## **MUKILTEO FERRY TERMINAL (PHASE 2) FERRY TERMINAL CONSTRUCTION**

VOLUME 2 OF 8

VOLUME 2 SHEET INDEX

C09.55  
SHEET  
245  
OF  
1521  
SHEETS

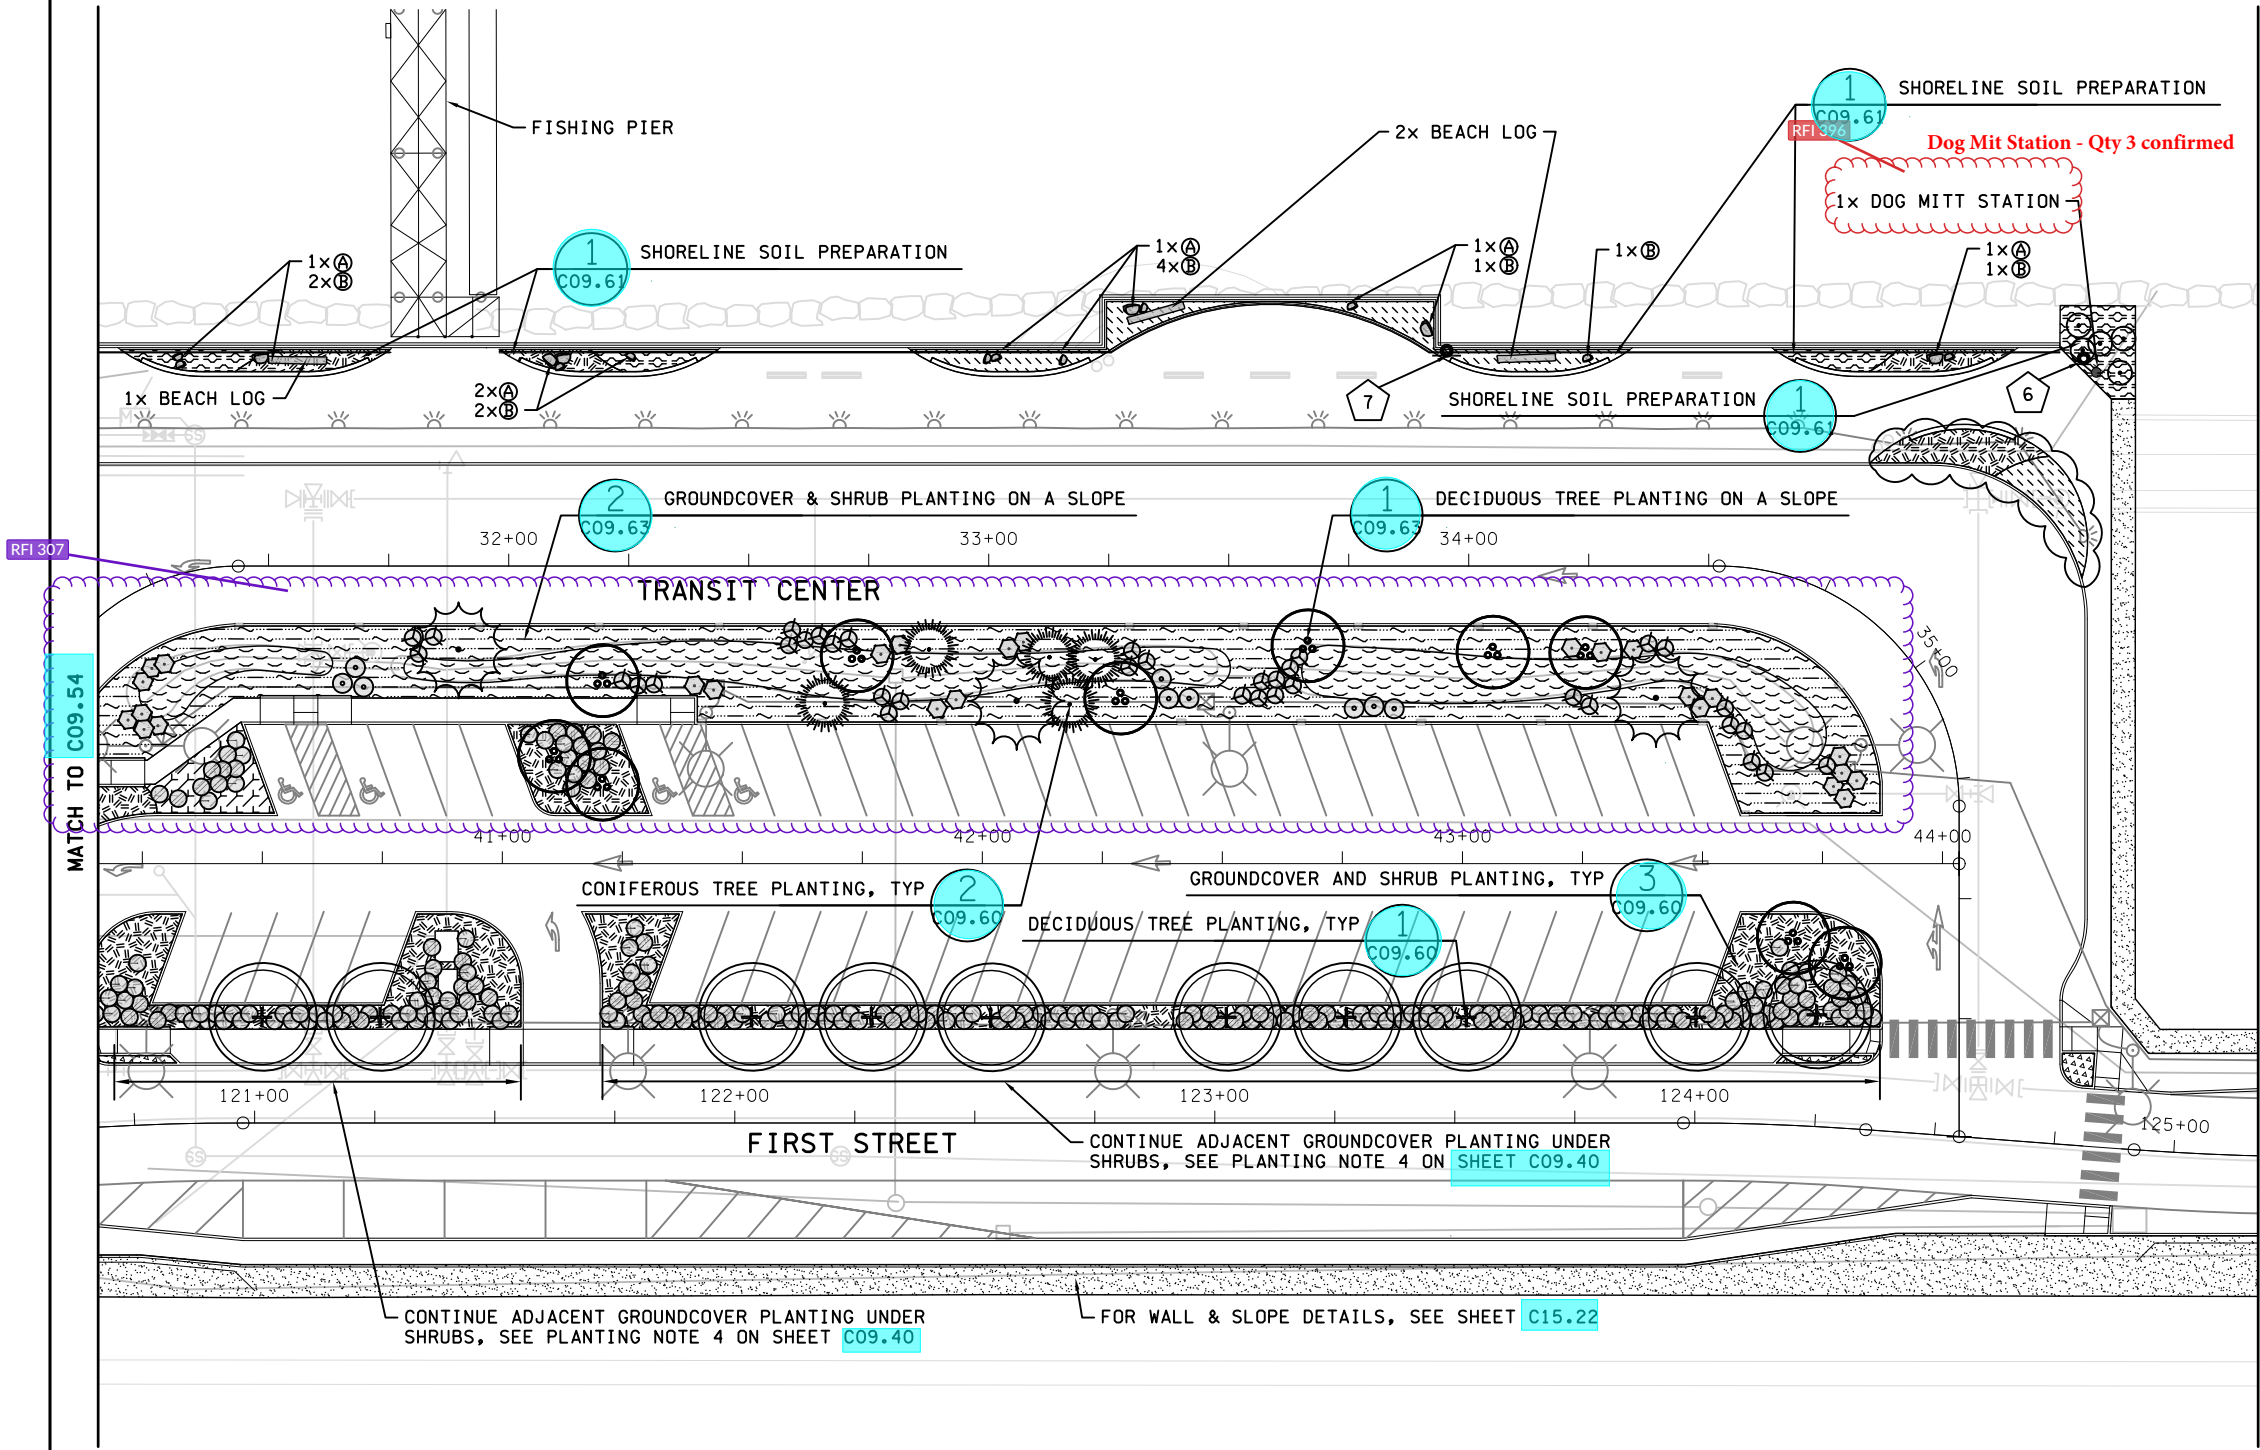
RFI 307 -

1. The bottom elevation is referring to the finished grade of the bottom elevation of the swale and is consistent for the entire section.
2. The point table refers to the bottom elevation at the point where the slope starts.

3. The areas between the swales is sloped and prepped for planting per sheet C09.55.
4. The intent of the 6" drain pipes is to connect the swale cells and convey water between the cells. The pipes should be set at the elevations shown which corresponds to the top of the 3" mulch layer.

5. The underdrain is set based on typical section 2/C07.37 which is generally 3' below the bottom elevation of the cell, and the underdrain is flat, like the cell bottom. The lowest cell is 17.5 which corresponds to an underdrain elevation of 14.5. In order to tie into the catch basin at elevation 15.5 the underdrain pipe will need to be raised for all three cells as shown in the attached drawing

SR 525 MUKILTEO FERRY TERMINAL (PHASE 2) FERRY TERMINAL CONSTRUCTION	C10.14A
PAVING PLAN	SHEET 256 OF 1521 SHEETS

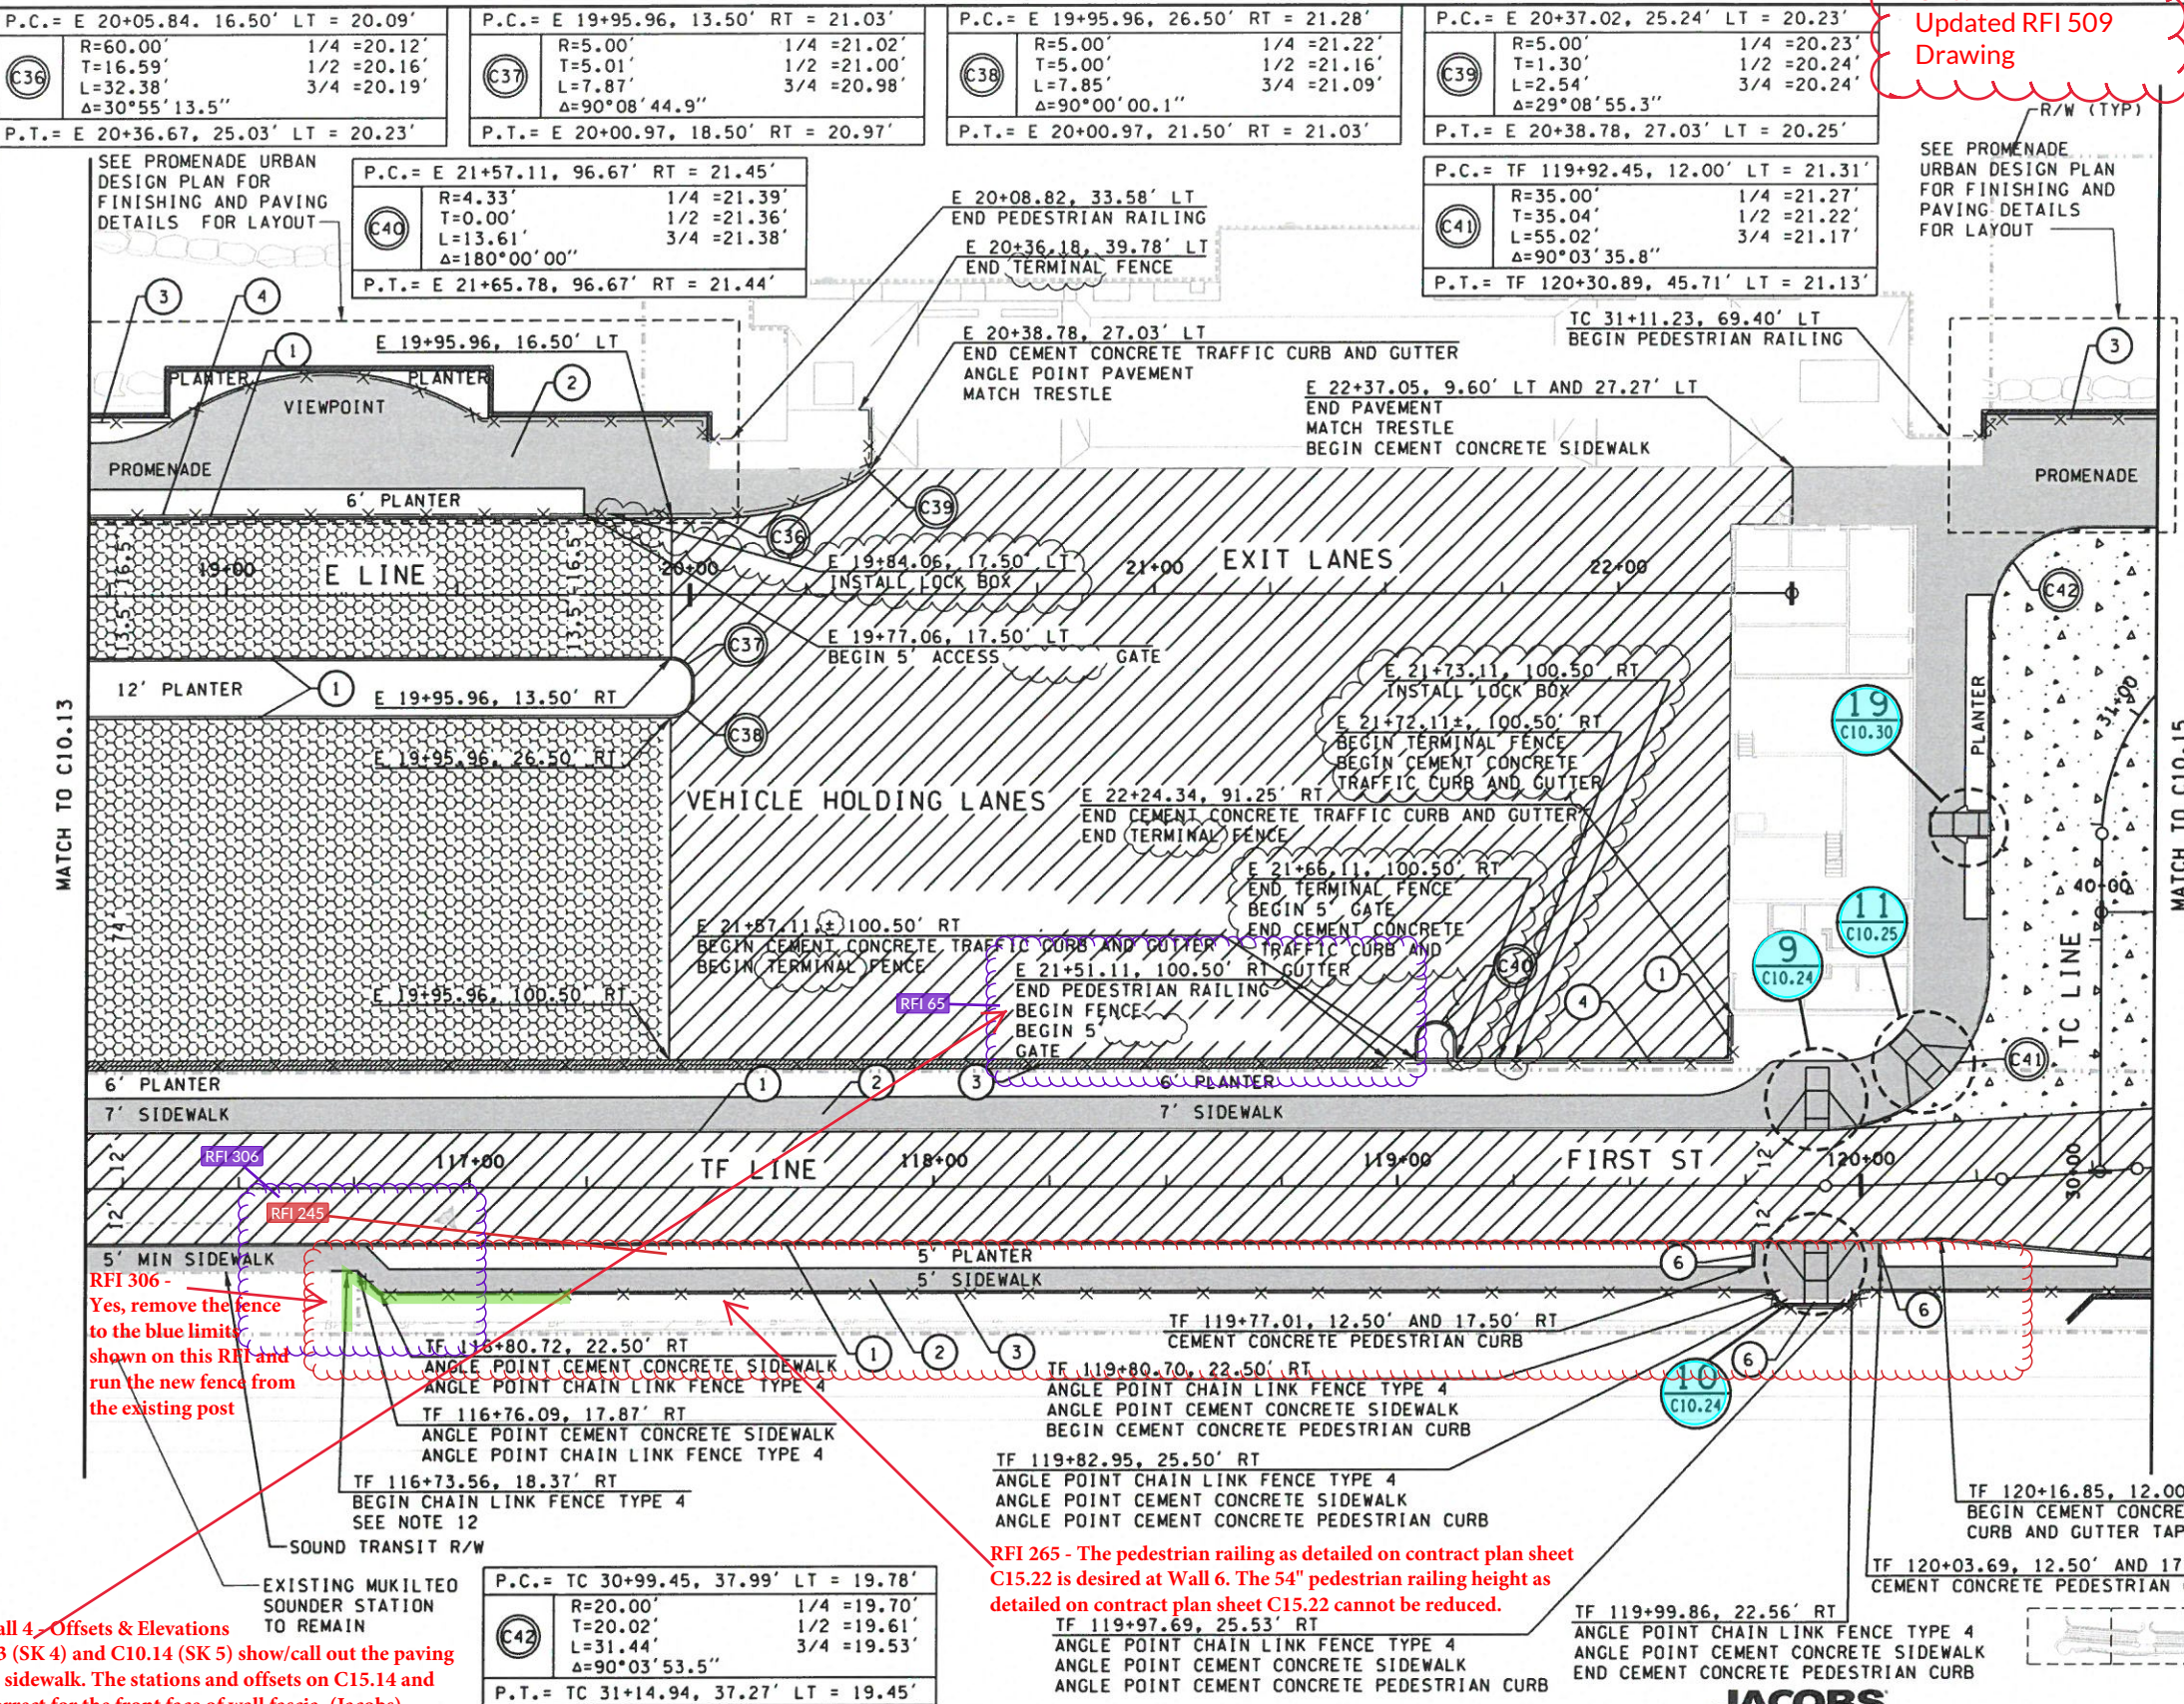
RFI 065 - Wall 4 - Offsets & Elevations  
Sheets C10.13 (SK 4) and C10.14 (SK 5) show/call out the paving limits for the sidewalk. The stations and offsets on C15.14 and C15.15 are correct for the front face of wall fascia. (Jacobs)

RFI 265 - The pedestrian railing as detailed on contract plan sheet C15.22 is desired at Wall 6. The 54" pedestrian railing height as detailed on contract plan sheet C15.22 cannot be reduced.

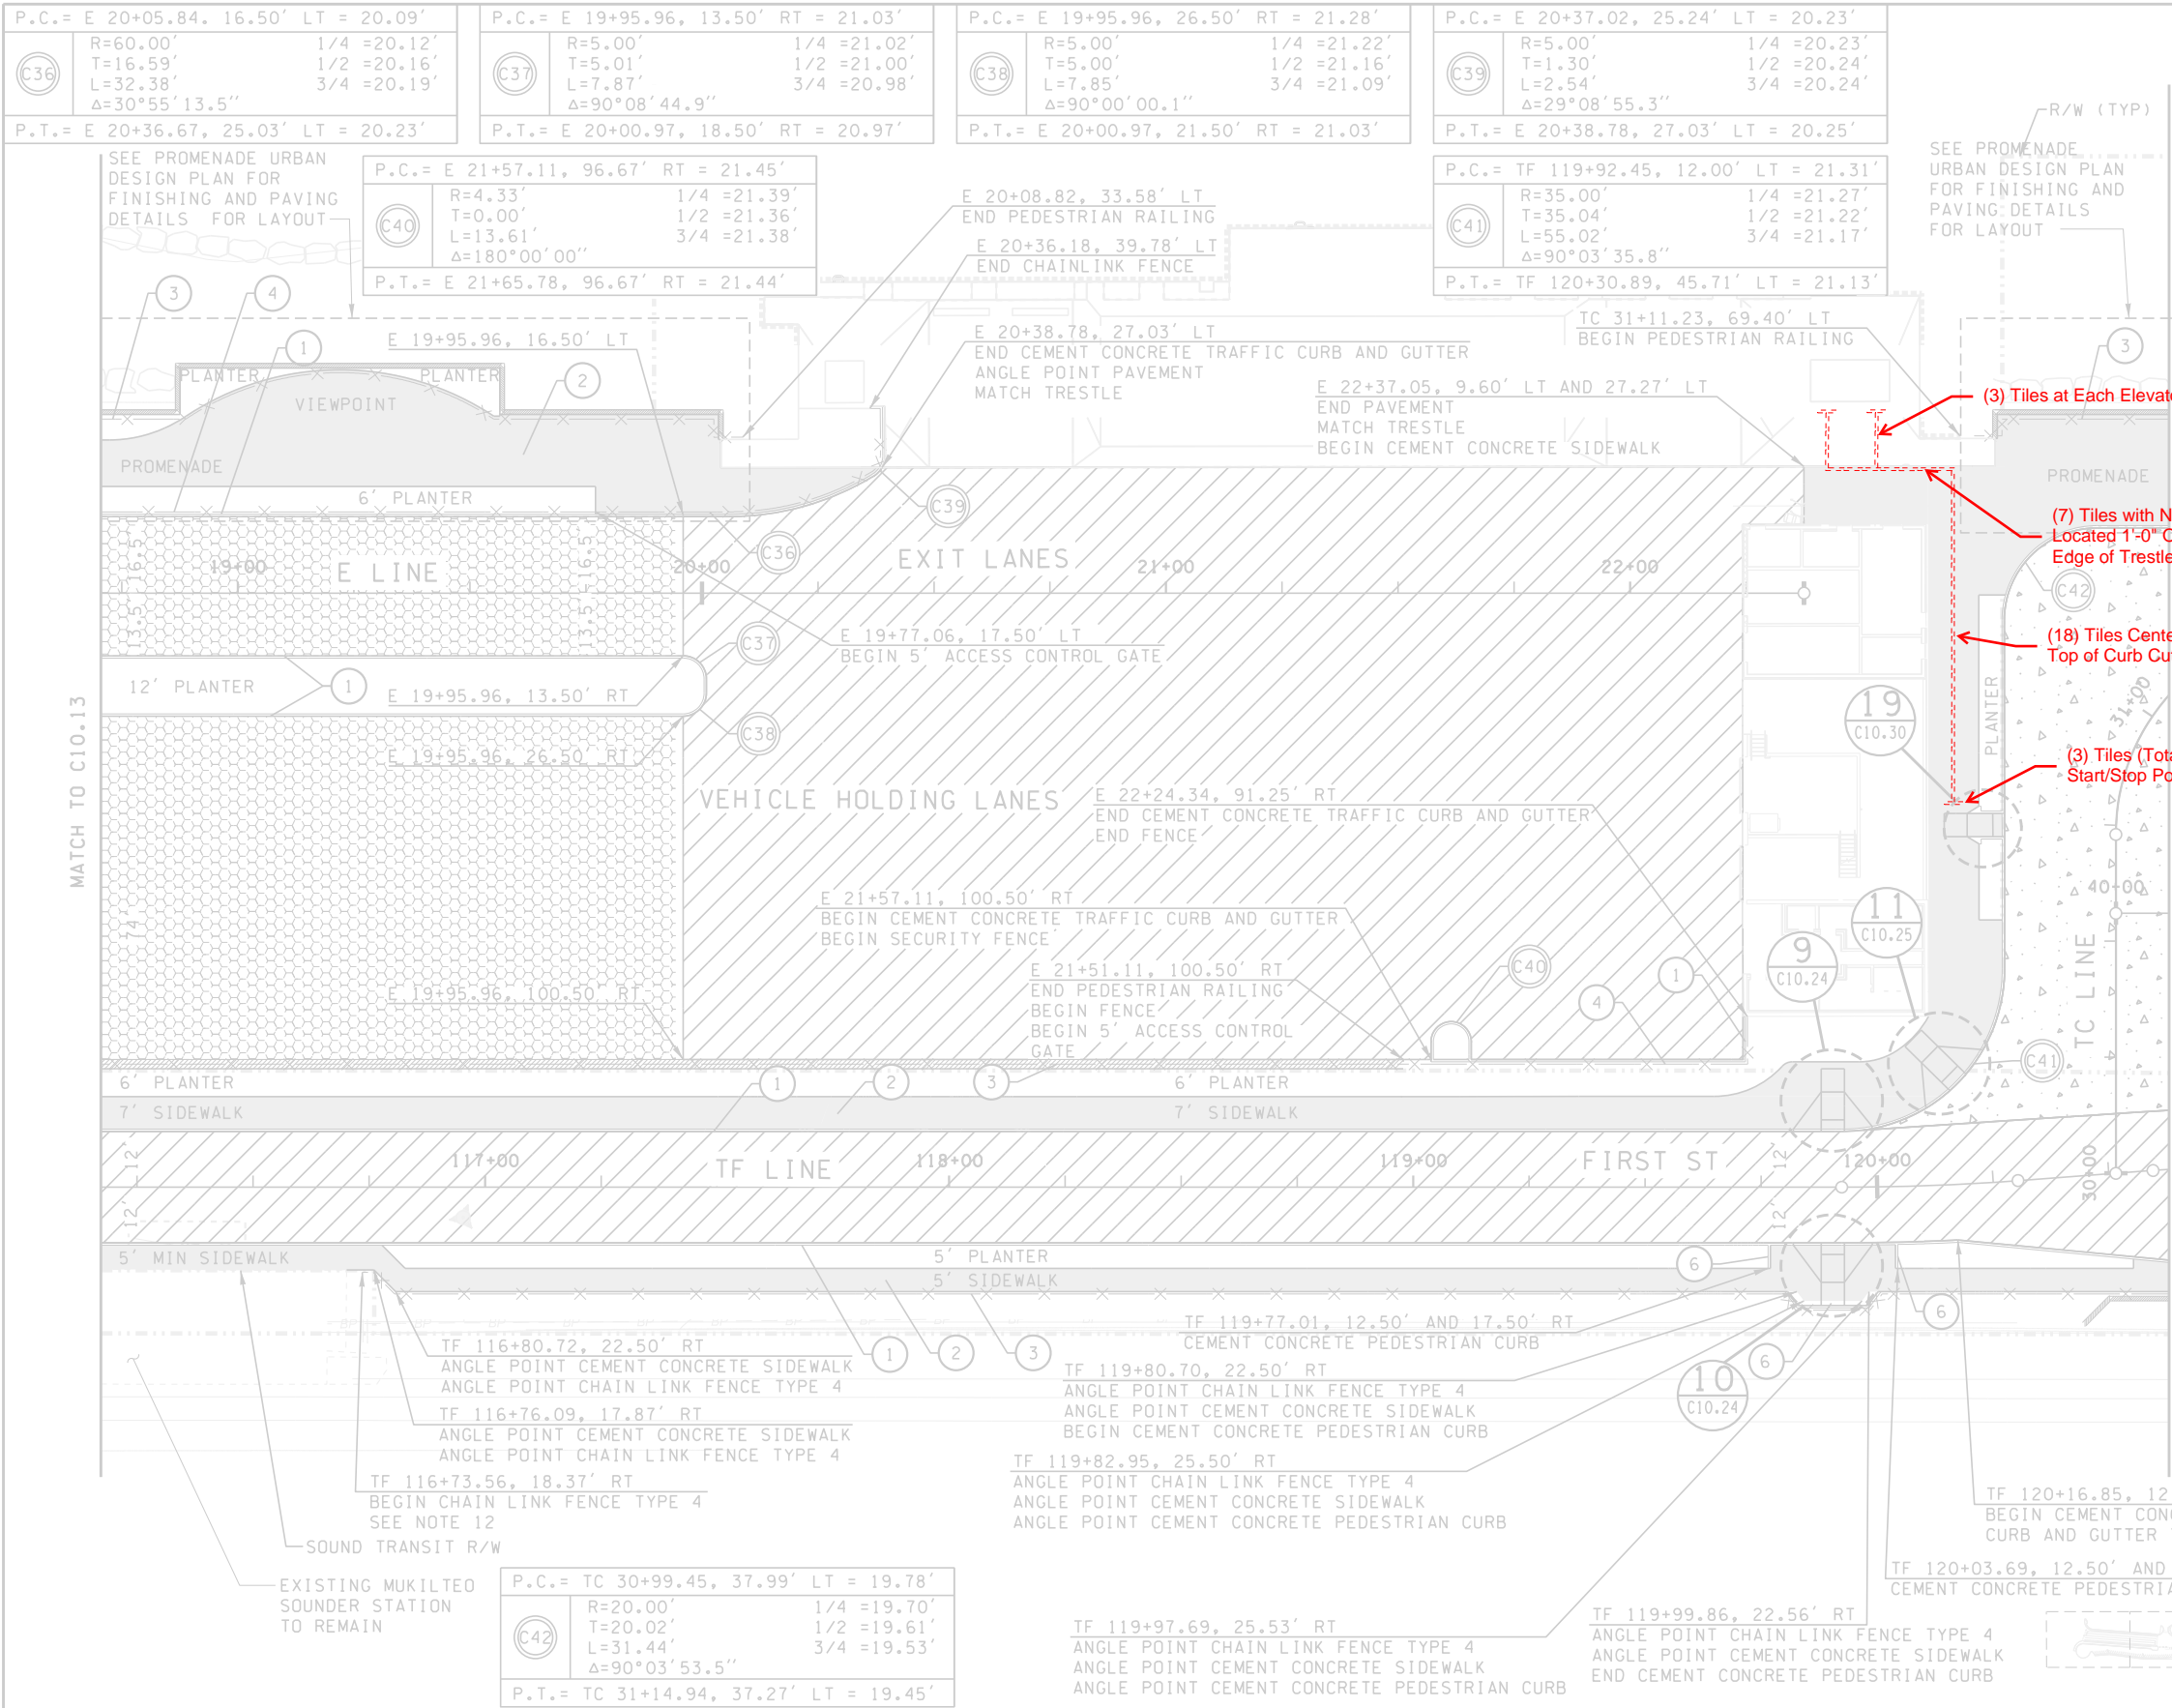
This drawing was marked up by D. Alire (KPFF) to show the ADA Directional Wayfinding ONLY. No other revisions were made to this drawing. The contractor shall use the Conformed C10.14 for all construction except the directional wayfinding added in red on this sheet. (KPFF, 5/19/2020)
